Rezoning Transportation Analysis

Petition Number: 2023-033

Date	Description
7-26-23	First Review (IW)
08-24-23	Second Review (NK)

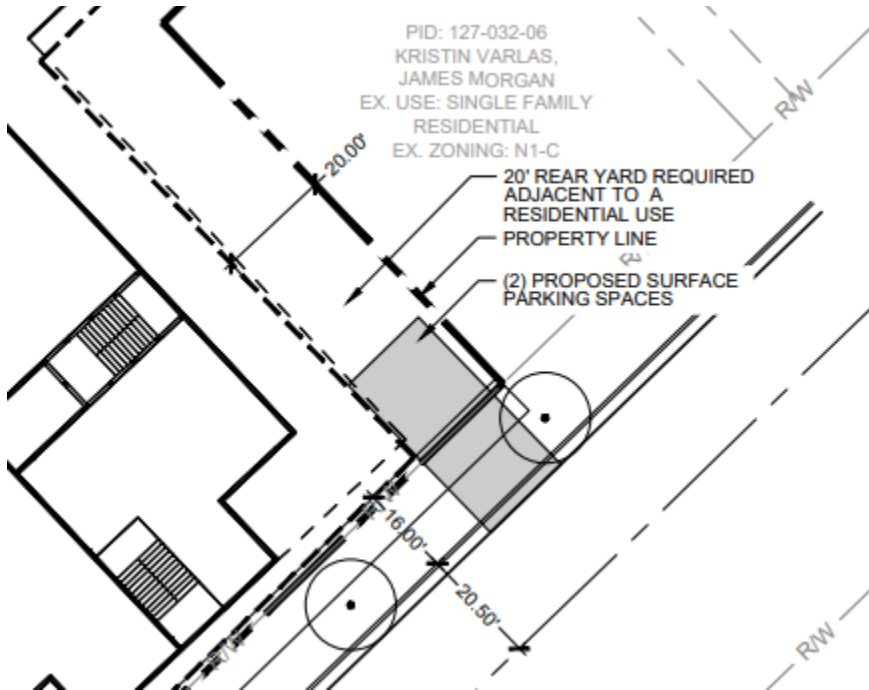
- ~~8. CDOT requests that the petitioner revise site plan and conditional note(s) to commit to upgrading the rapid flashing beacon pedestrian crossing at Clement Ave and E. 7th Street.~~
